ADDENDUM 1 – Issued 8/14/19

Sole Provider - Great Rivers Greenway Trail Signage Fabricator

1 FRONT ELEVATION - SIGN FACE LAYOUT
3/4" = 1'-0"

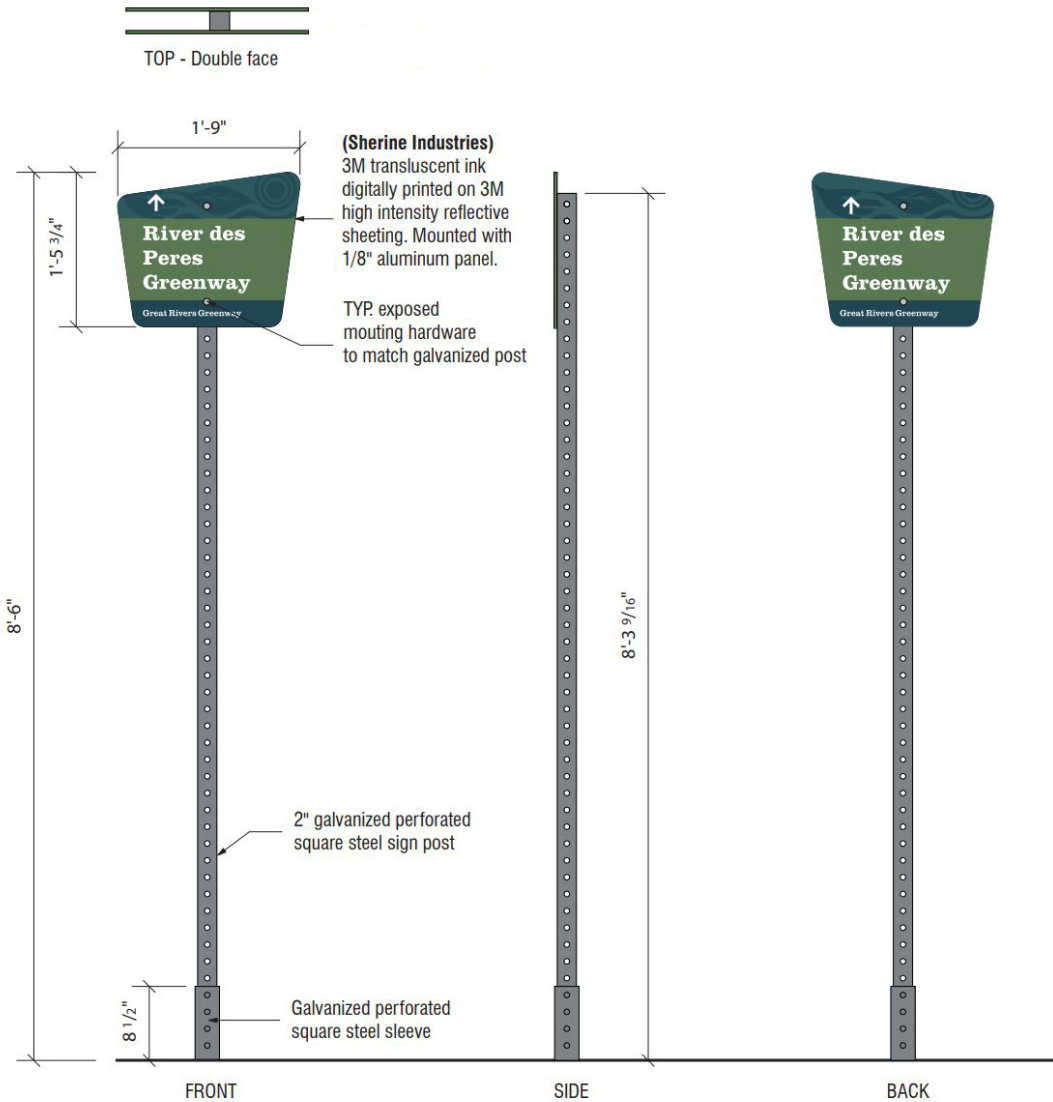
This addendum is for the requested sign panel sample for Sign Type Gx-4. The panel thickness has been added and the material has changed from what was included in the Exterior Sign Design Standards Guide originally posted on 8/8/19. A new standards guide has been posted here <https://greatrivergreenway.org/bid/request-for-qualifications-sole-provider-of-greenway-signage/> Below is the detail from page 22 of the guide showing the updated sign panel specs:
